ISO/
IEC/IEEE
8802-1CB

AMENDMENT 2
2023-02

**AMENDMENT 2: Extend stream
identification functions**

**Amendment 2: Extended Stream Identification
Functions**

Figure 11-1—MIB modules structure

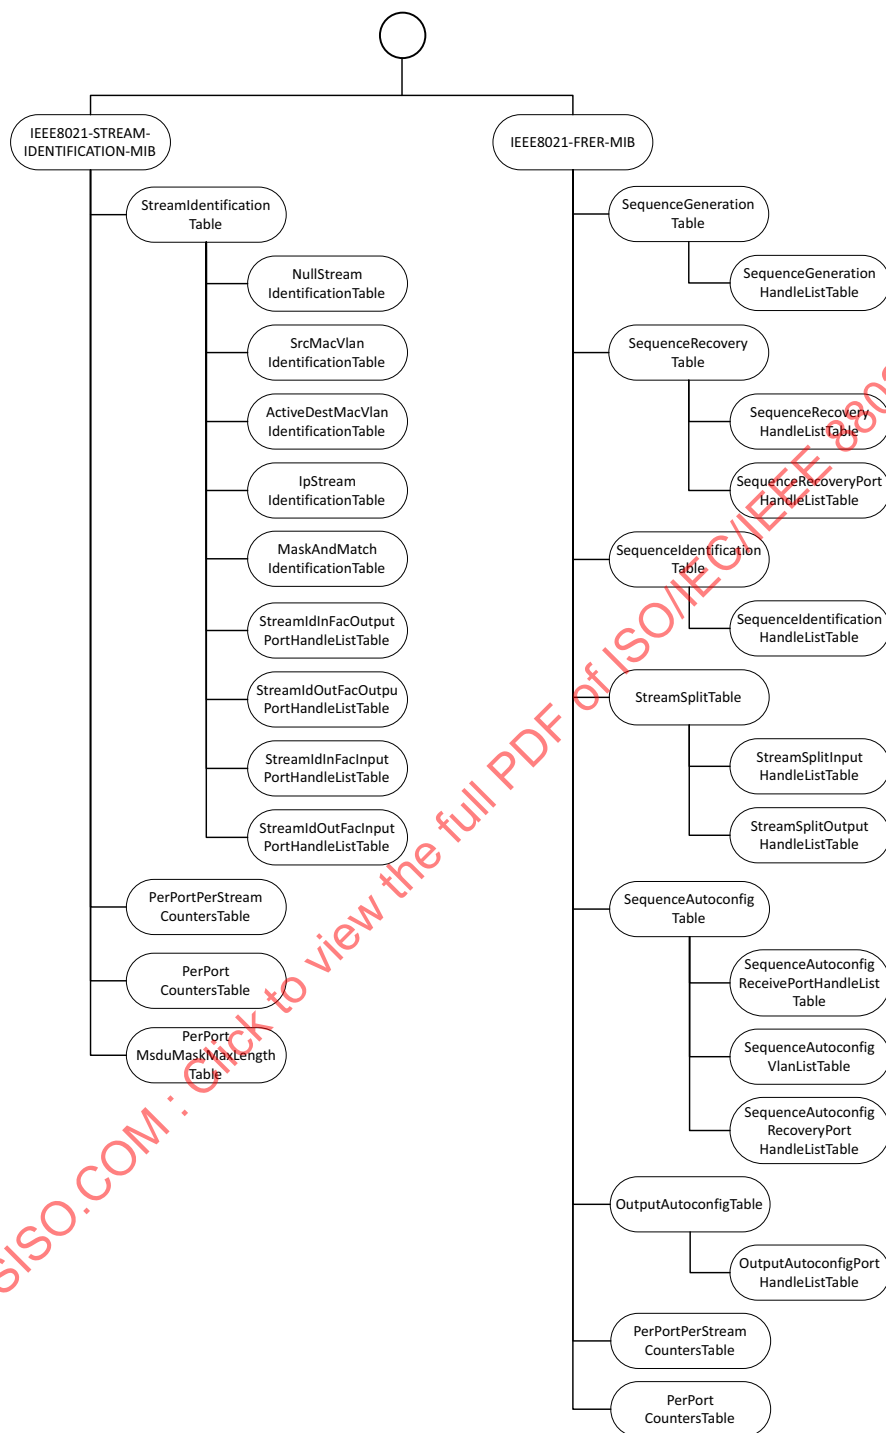
Replace Figure 11-1 with the figure shown on the next page (with “MaskAndMatch IdentificationTable” and “PerPort MsduMaskMaxLength Table” added):

Figure 12-3—Stream identification model

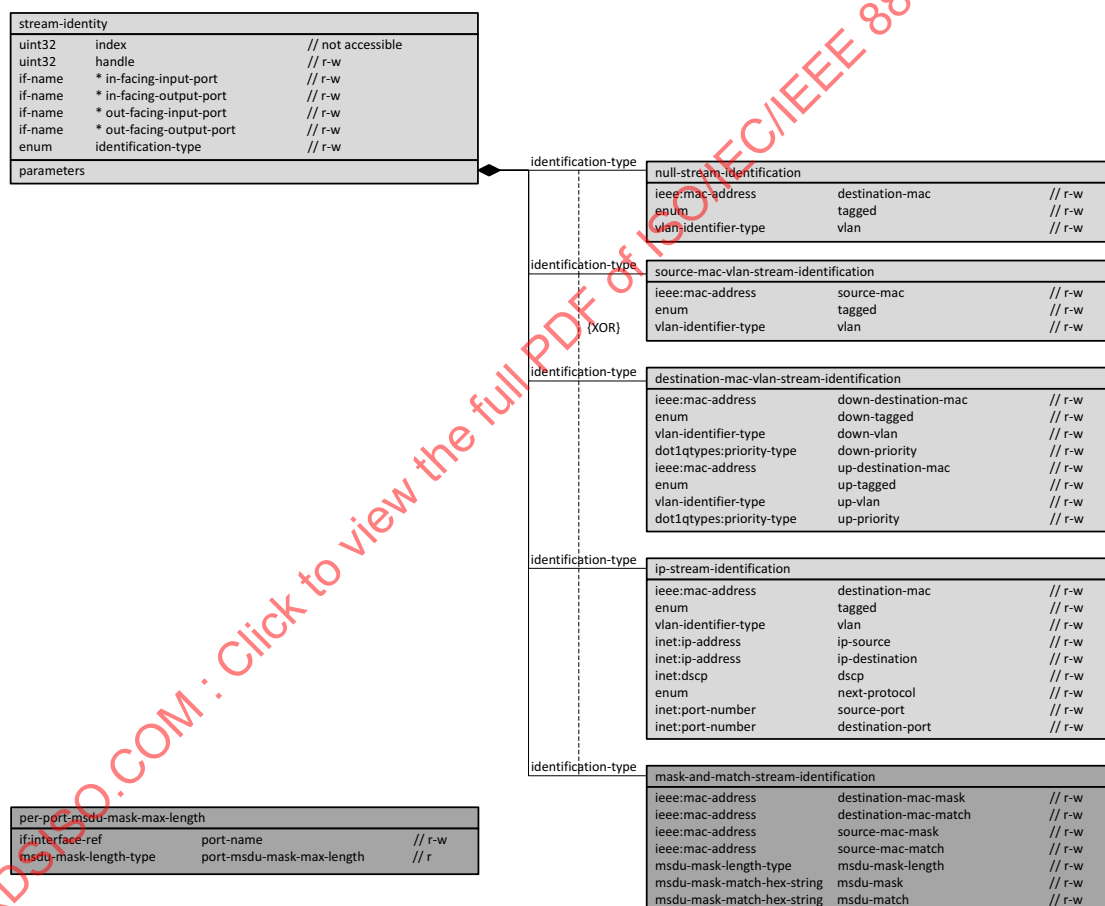
Insert the following note after the first paragraph of 12.2.1 and before Figure 12-3:

NOTE—The {XOR} UML constraint denotes that the stream-identity parameters can be either one of the identification-types described on the right-hand side of the diagram.

Replace Figure 12-3 with the following figure (with darker-grey background boxes added).
